CULTURAL RESOURCES OFFICE
PRESERVATION BOARD
REGULAR MEETING
MONDAY, JANUARY 29, 2024 — 4:00 P.M.
1520 MARKET ST, SUITE 2000, ST. LOUIS, MO 63103
www.stlouis-mo.gov/cultural-resources

DATE: January 29, 2024
ADDRESS: 3228 Copelin Avenue
ITEM: Construct single family house with attached garage
JURISDICTION: Compton Hill Certified Local District
NEIGHBORHOOD: Compton Heights
WARD: 6
OWNER: Ryan Stewart & Mollie Neil
ARCHITECT: Bob Buckman
STAFF: Jan Cameron

DATE: January 29, 2024
 ADDRESS: 2928 Minnesota Avenue
 ITEM: Demolish 1½-story brick house and construct new single-family residence
 JURISDICTION: Tower Grove East Historic District; Tower Grove East National Register District; Preservation Review District
 NEIGHBORHOOD: Tower Grove East
 WARD: 7
 OWNER: Kaveh Razani
 ARCHITECT: Revel Architects
 STAFF: Jan Cameron/Meg Lousteau

FIRST FLOOR PLAN—NOTE FRONT ENTRY DRIVE & PARKING AREA (LOWER RIGHT) WOULD BE REMOVED FROM PROJECT

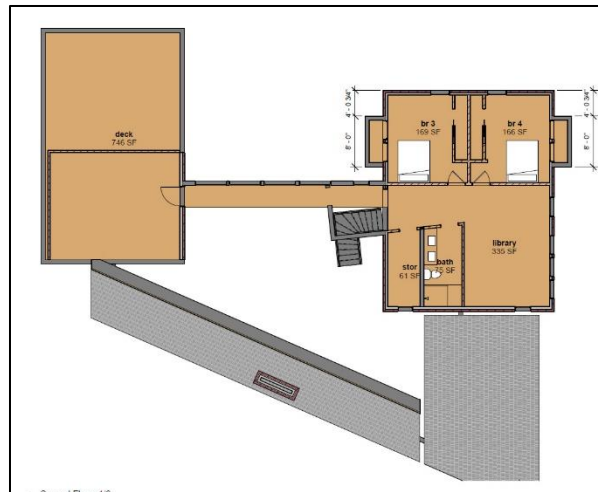
The owners have agreed to comply with this stipulation and remove the front drive and front parking area shown on the drawings.

PROPOSED NEW CONSTRUCTION – EAST (MARCONI) ELEVATION

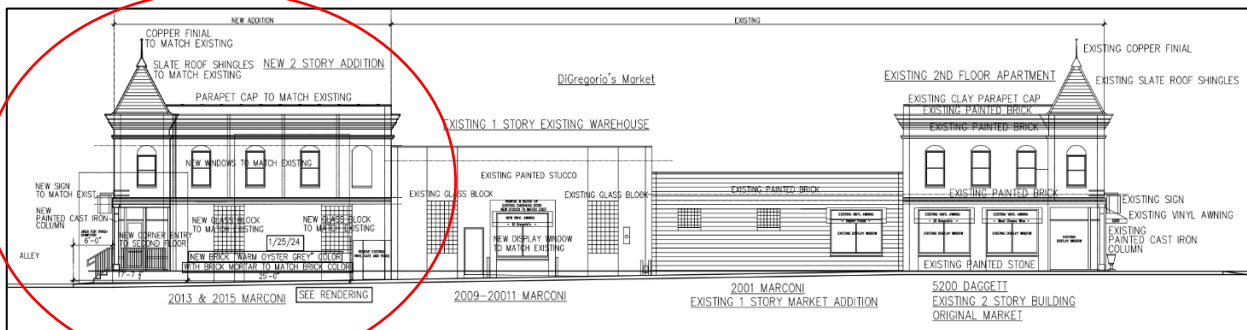
The proposed new construction would be a two-story brick building that would generally mirror the existing historic corner building at Marconi and Daggett, adding a fifth bay along Marconi but otherwise replicating its massing, materials, and brick detailing, and largely replicating its corner entrance and fenestration patterns. Along the Marconi side, in place of glass windows there would be glass block, and along the alley side there would be a loading dock. The exterior material would be unpainted brick, in a warm gray a few shades darker than the adjacent buildings, to be harmonious with the original structures but distinguish it as a later addition.

PROPOSED AND EXISTING SITE PLANS

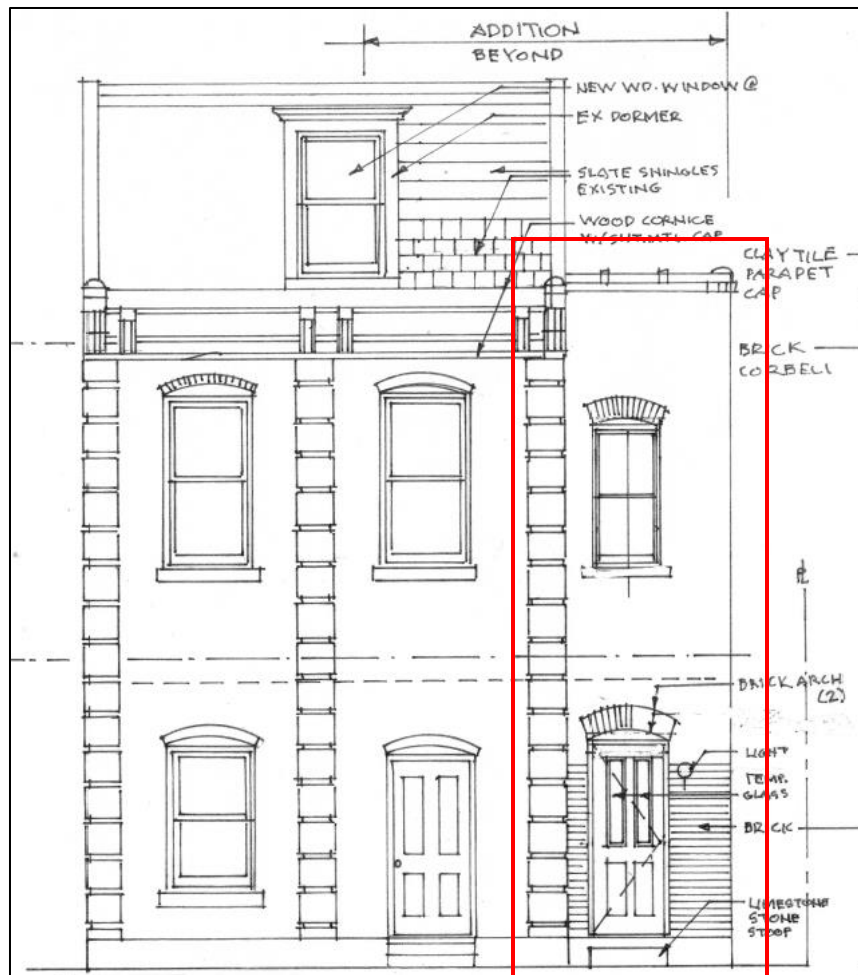
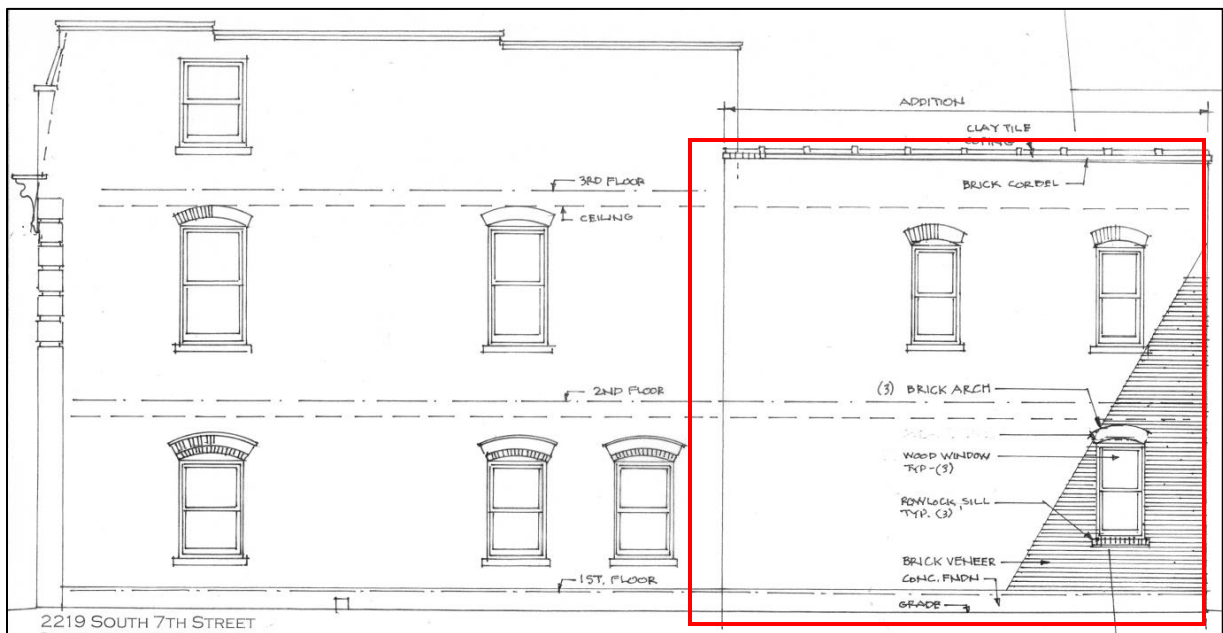
Does not comply. The proposed new all-brick addition would be located on a Semi-Public Façade. However, it should be noted that the applicants have worked with CRO staff and the neighborhood review committee to produce a design that is complementary to the building and the streetscape. Though not technically compliant with the standards, the revised design would otherwise be appropriate in

scale, materials and detail. Ell extensions are common on buildings across Soulard and other neighborhoods in the city of St. Louis.

PROPOSED FRONT ELEVATION

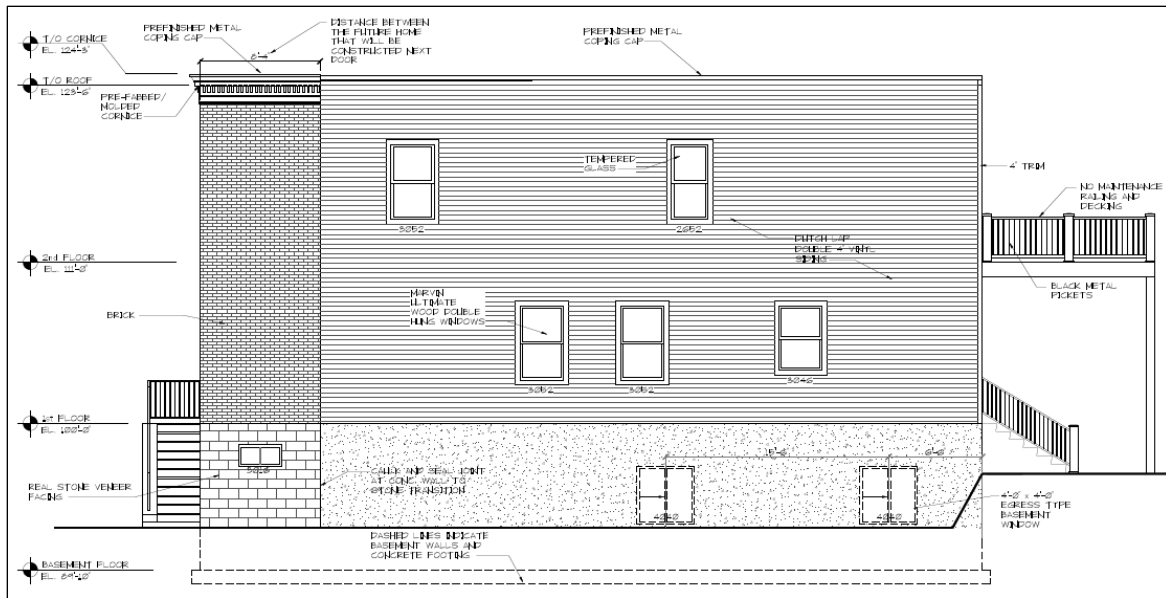
The applicant has provided an appropriate Model Example at 2356 S. 10th St. The main deviation from the Model Example building is that the Model Example has a side gable roof, and the new construction proposes a flat roof. This change has a substantial impact on the appearance of the building.

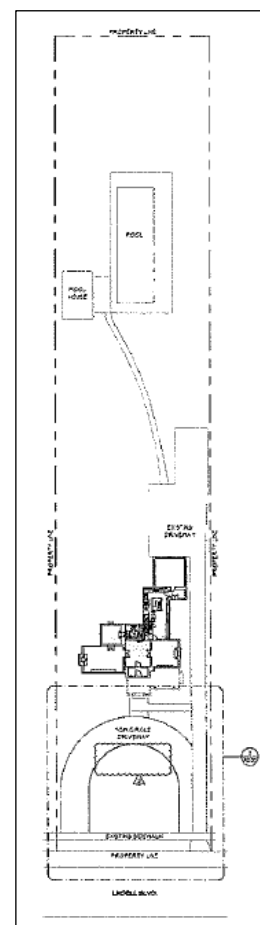
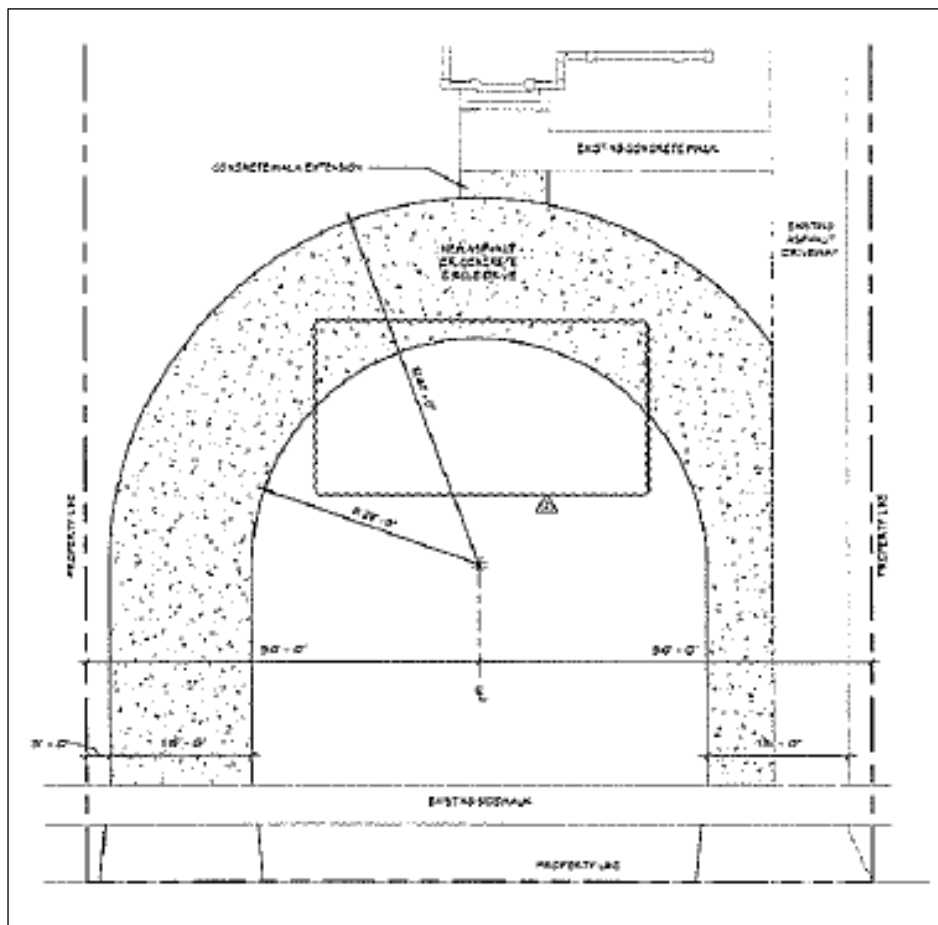
Does not comply. The proposed new circle drive would involve additional paving of the front yard.
